SAM'S CARWASH CONDITIONAL USE NO. CU202503

Conditional Use Application

Sam's Carwash, Conditional Use Application No. CU202503– Request for Conditional Use approval to allow a Car Wash in the CRT-1.75, C-1.0, R-0.75, H-55 Zone, located at 26203 Ridge Road, Damascus.

MCB ITEM NO. 8

CONDITIONAL USE PLAN

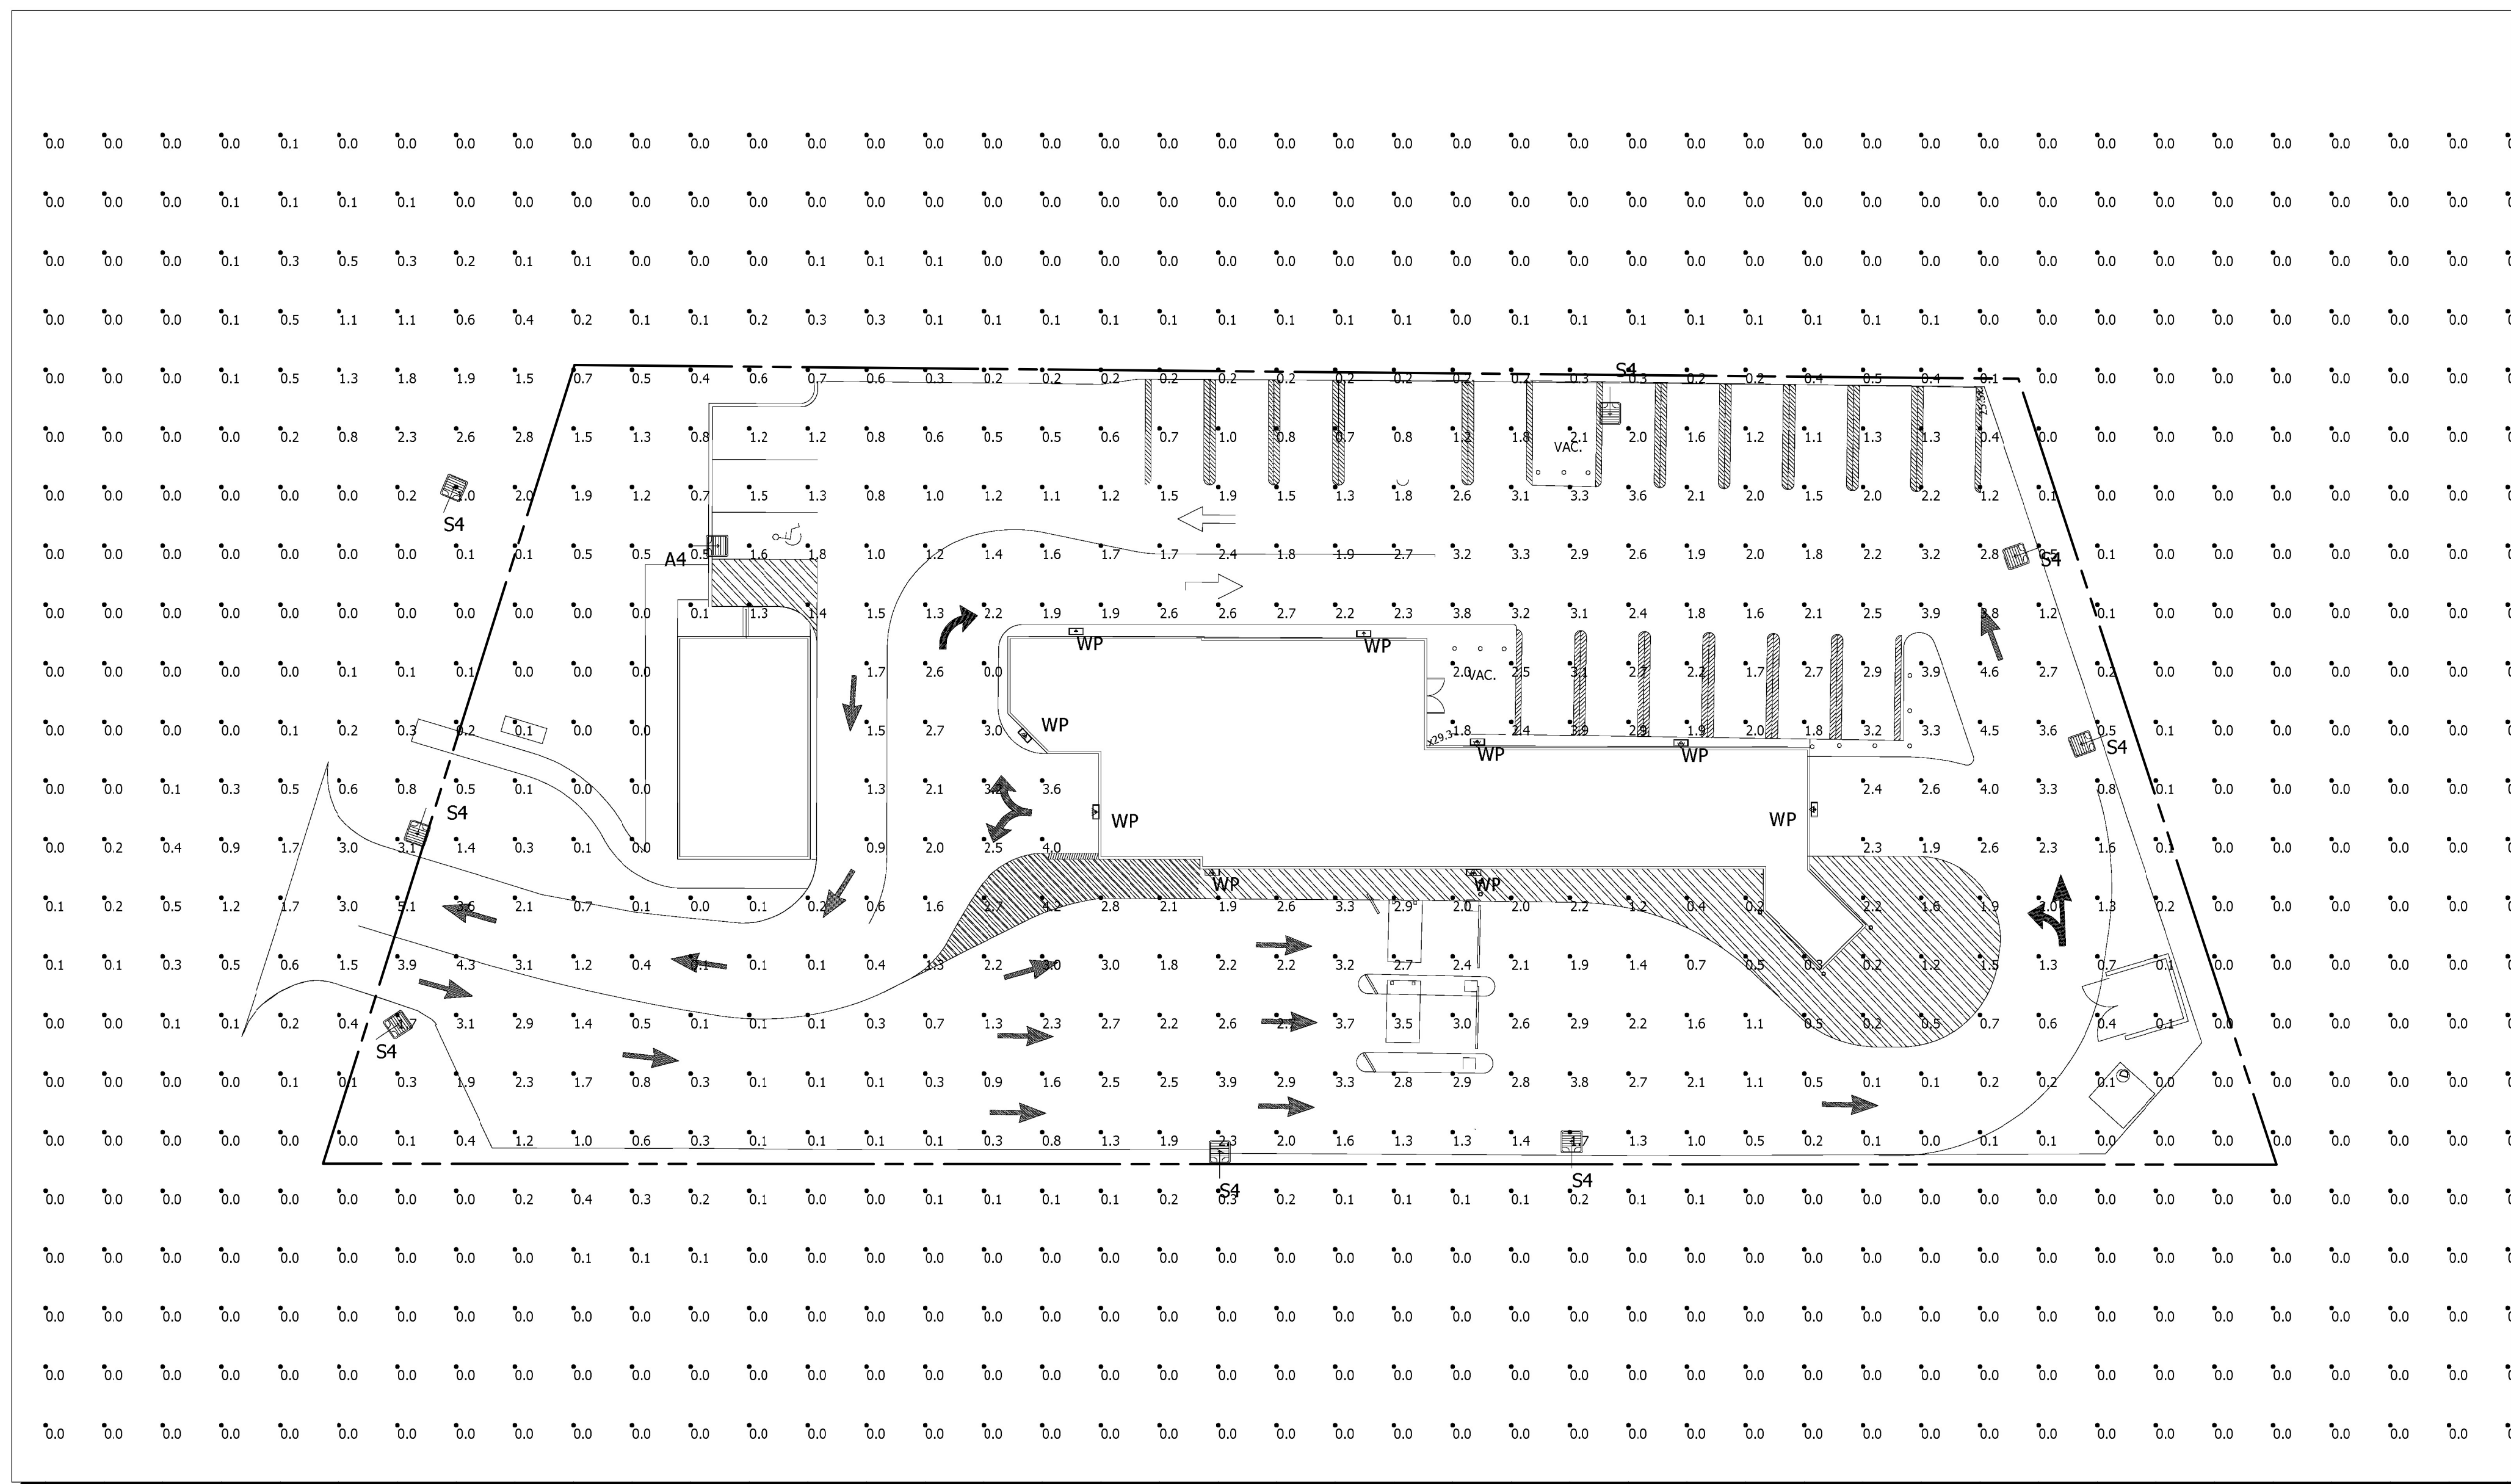
We have completed our review of the updated conditional use plan dated February 7, 2026, which was received via email on February 25, 2026. A previous version of this plan was reviewed by the Development Review Committee at its October 8, 2024, meeting. This plan is tentatively scheduled for the March 26, 2026, Planning Board hearing. We recommend approval of the plan subject to the following comments:

2. Ridge Road (MD 27) is classified as a town center street with a minimum right-of-way (ROW) of 80-feet. We recommend that the applicant dedicate forty feet from the existing centerline to comply with the master plan.
